**DIVISION STREET SHARED USE PATH
WILTON, IOWA**

ADDENDUM NO.1

February 7, 2024

Remove and replace the following plan sheets. A brief description of the changes on each sheet is provided for clarification.

DIVISION STREET PROPOSED TRAIL

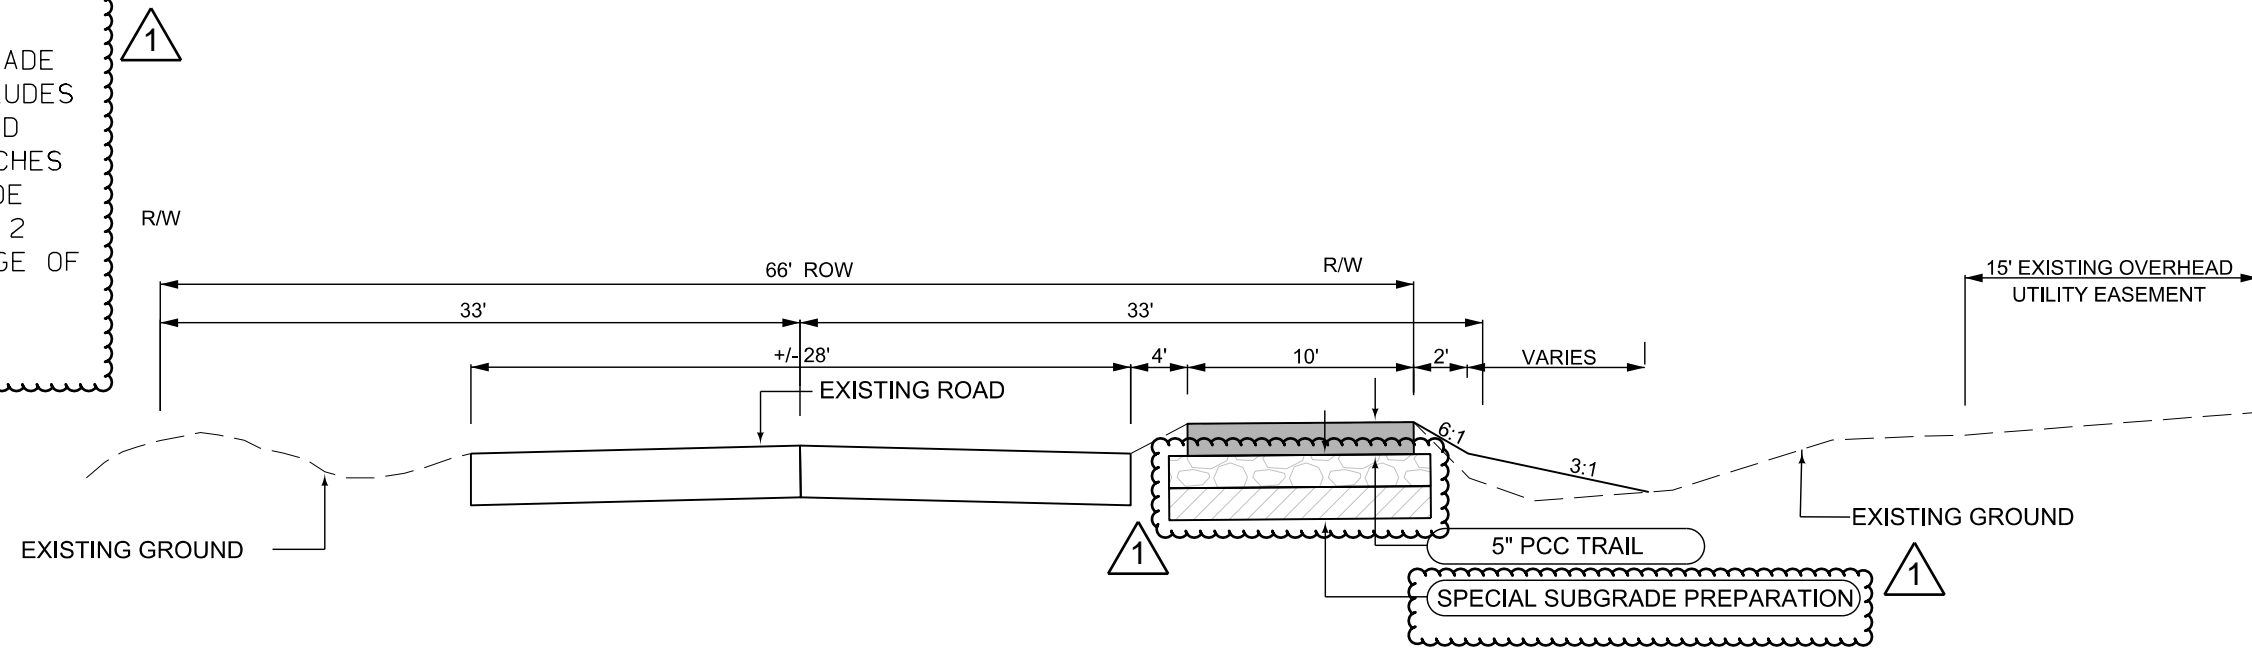
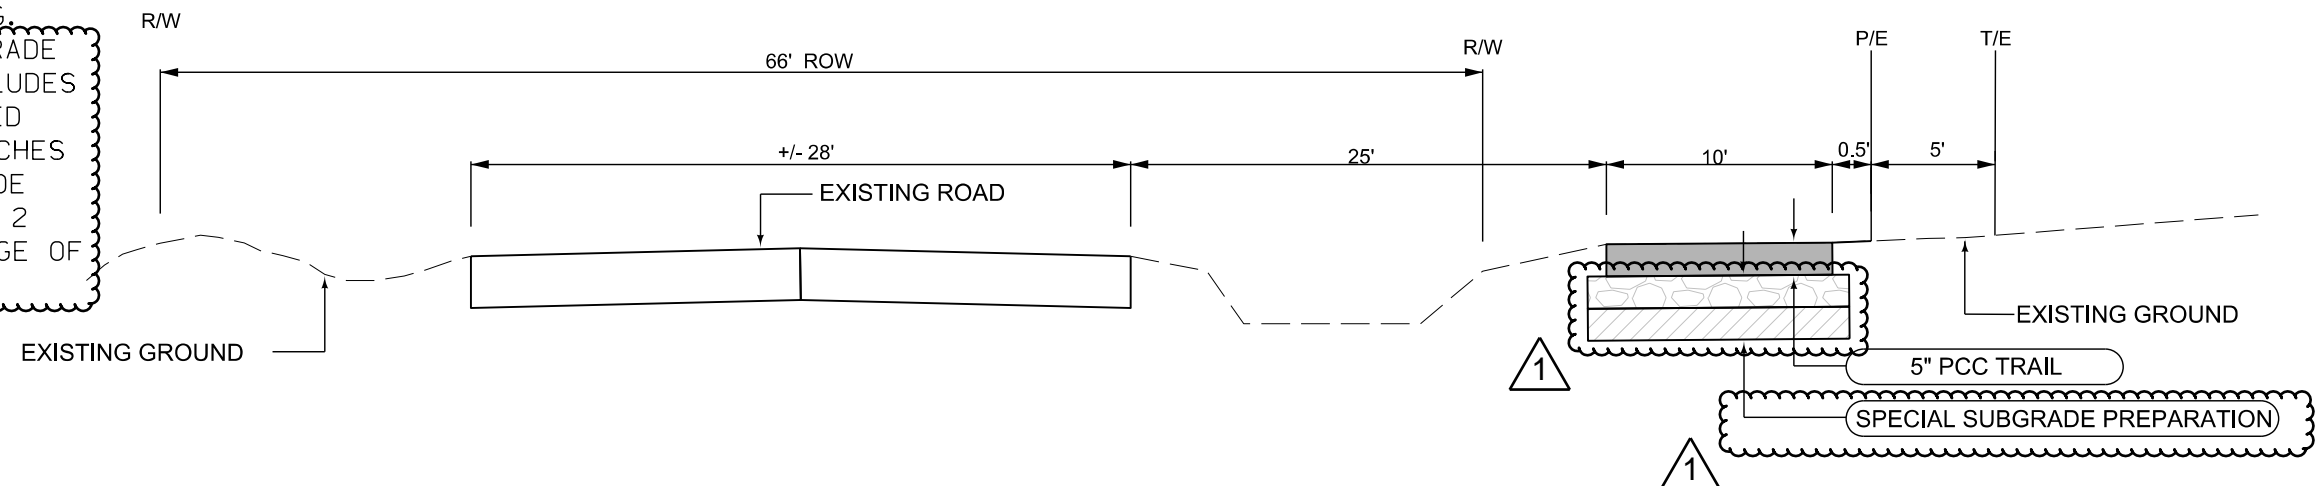
2. Sheet B.01 the typical sections have been updated to show the Special Subbase Preparation item along with a note regarding this item.
3. Sheet C.01 has updated the Estimated Project Quantities table to reflect the new bid item at quantity provided.
4. Sheet C.02 has rearranged the prior tabulations on the sheet and now includes the continuation of the Estimate Reference Information to its conclusion.

NOTES:
 1. SPECIAL SUBGRADE PREPARATION INCLUDES 4 INCHES MODIFIED SUBBASE ON 6 INCHES MODIFIED SUBGRADE PREPARATION FOR 2 FEET OUTSIDE EDGE OF TRAIL.

2. SPECIAL SUBGRADE PREPARATION INCLUDES 4 INCHES MODIFIED SUBBASE ON 6 INCHES MODIFIED SUBGRADE PREPARATION FOR 2 FEET OUTSIDE EDGE OF TRAIL.
